Change Order

Ketchum Fire Station #1
107 Saddle Road, Ketchum, ID

Change Order Number: 008
Date: August 11, 2021

See attached spreadsheet of seven items.

SECTION DETAIL @ RAILING SILL

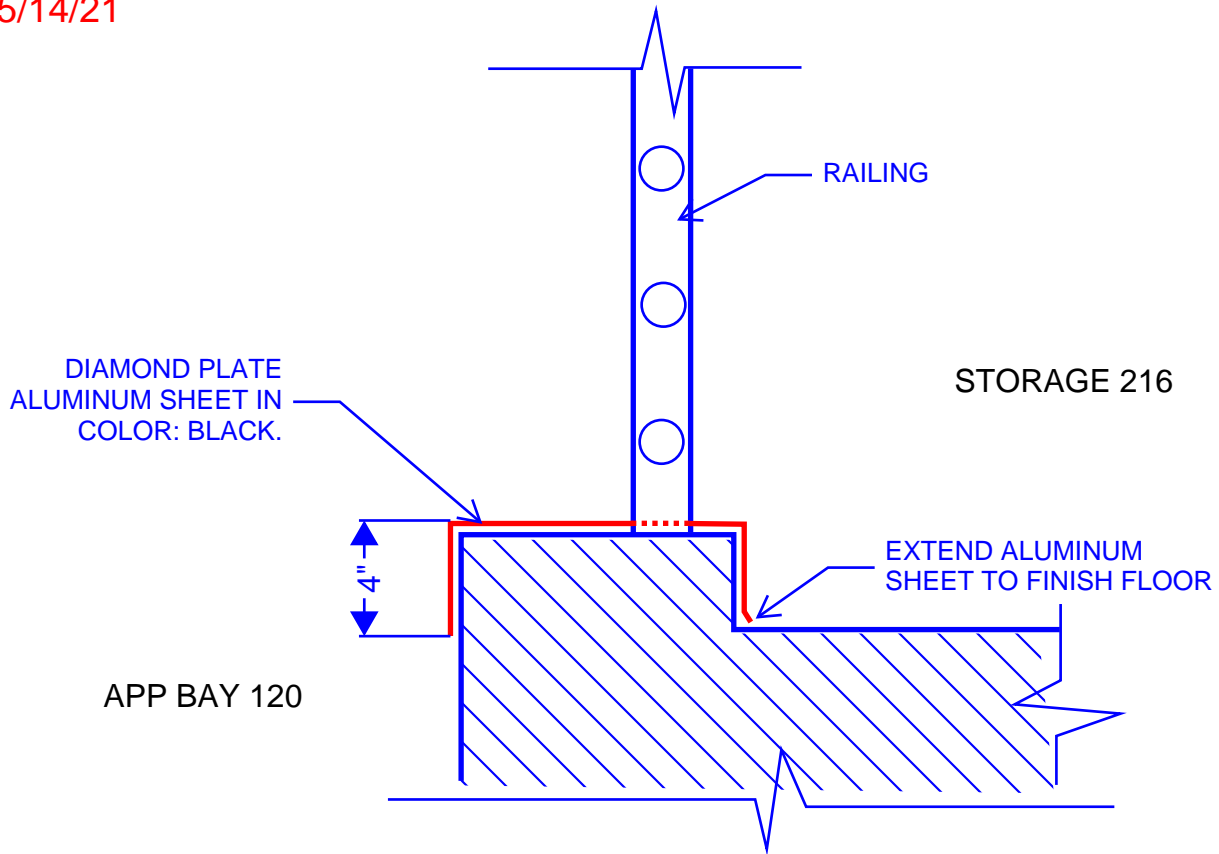
Please confirm design intent for the sill condition at the guardrail and gate opening as section 4/A2.81 does not show the correct condition.

Provide diamond plate aluminum sheet in color: black.
Wrap sheet over the sill in sections. See detail sketch below.

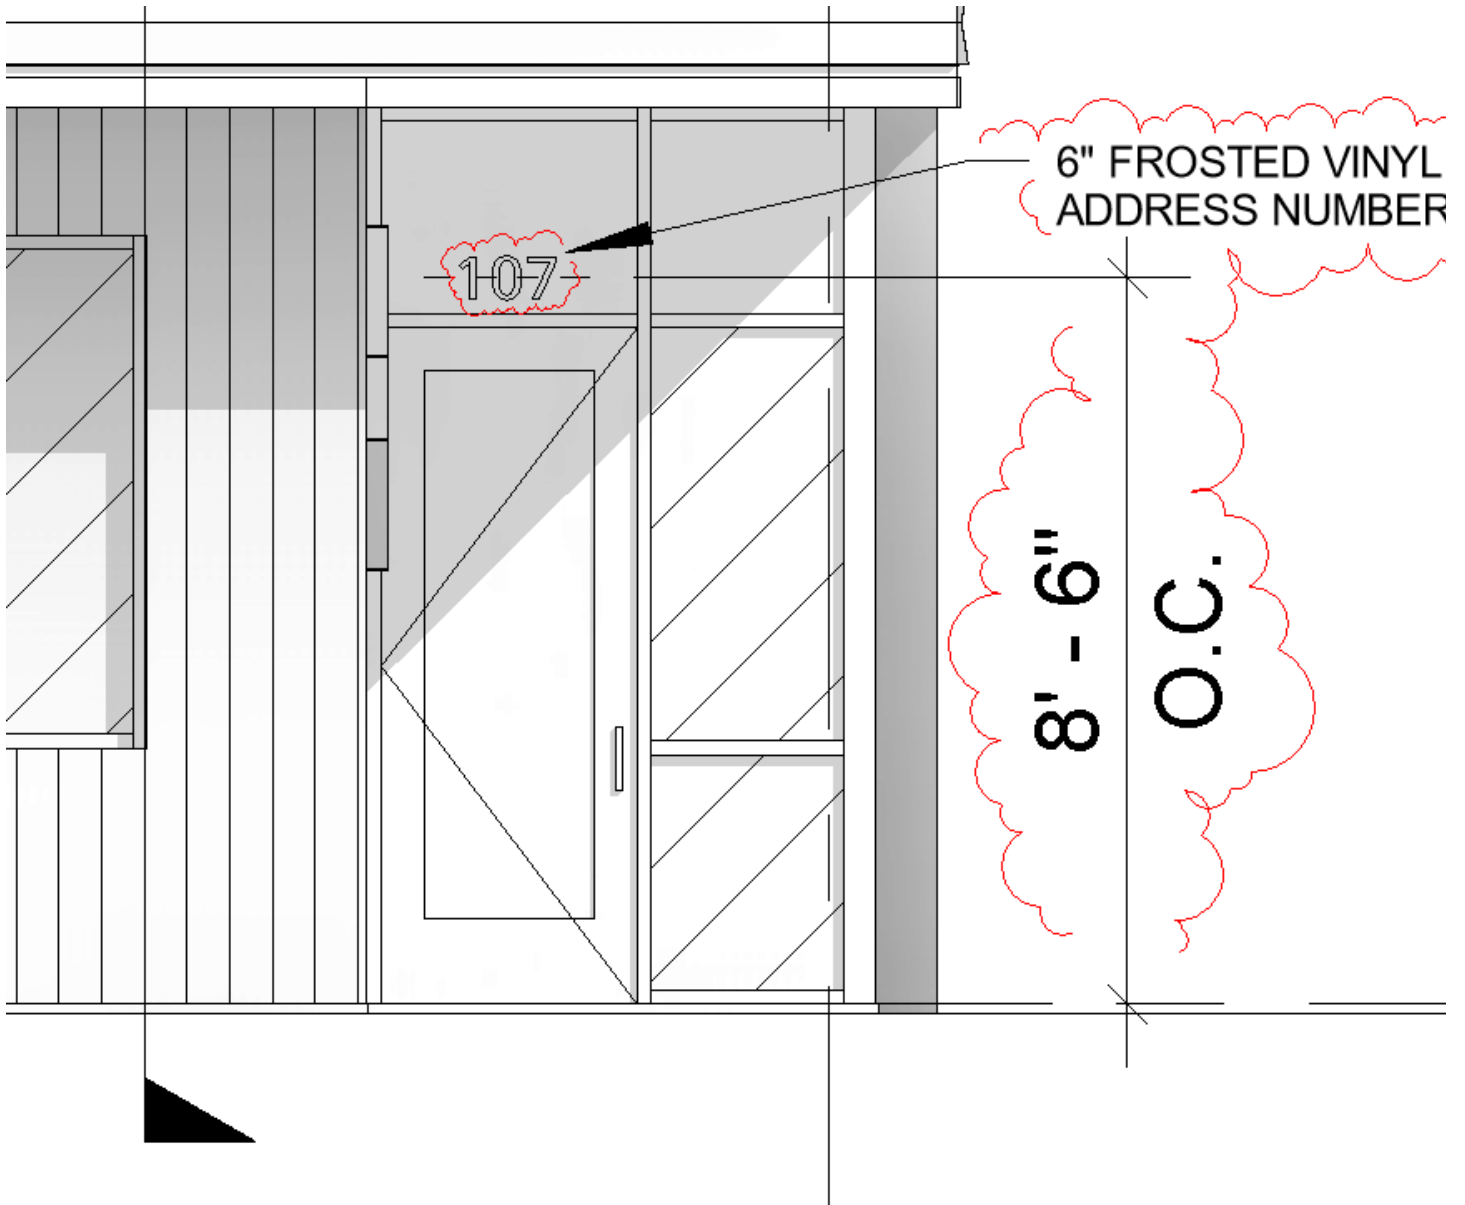
Looks good to me.

**FLOOR PLAN -
LEVEL 01**

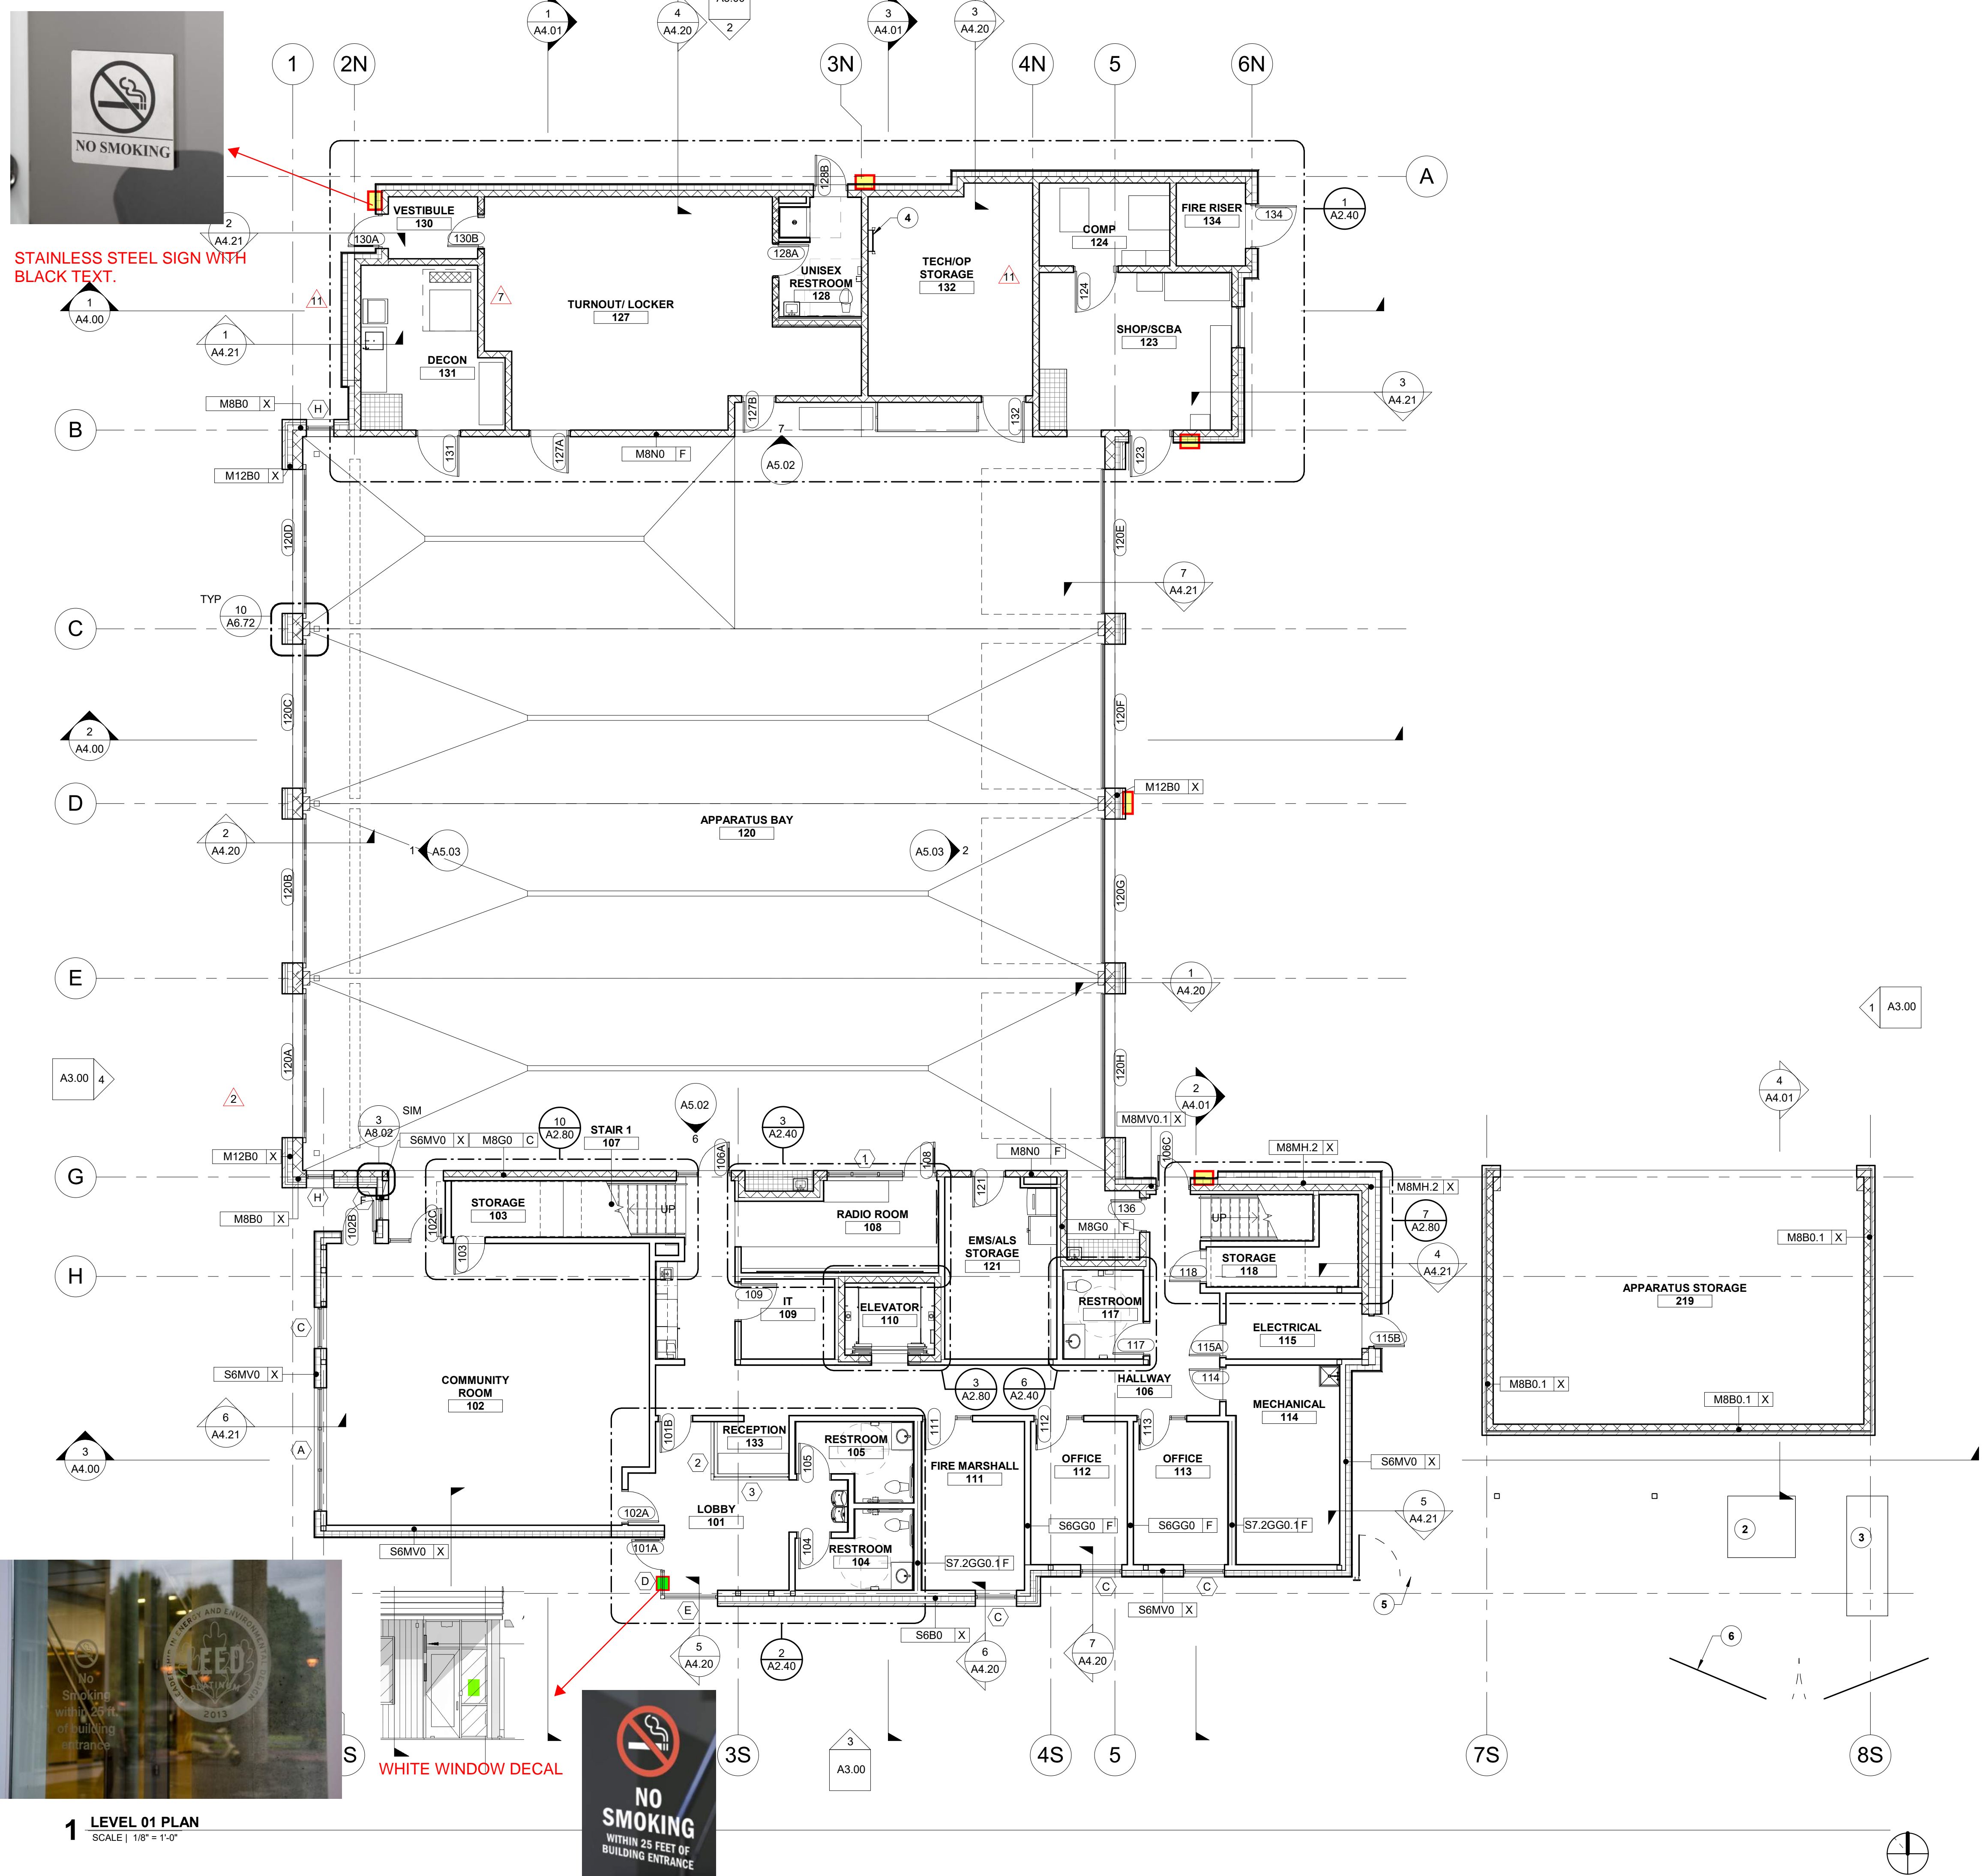
Add exterior signage per sheet A2.01 "No Smoking Signage Proposed Locations" Sheet
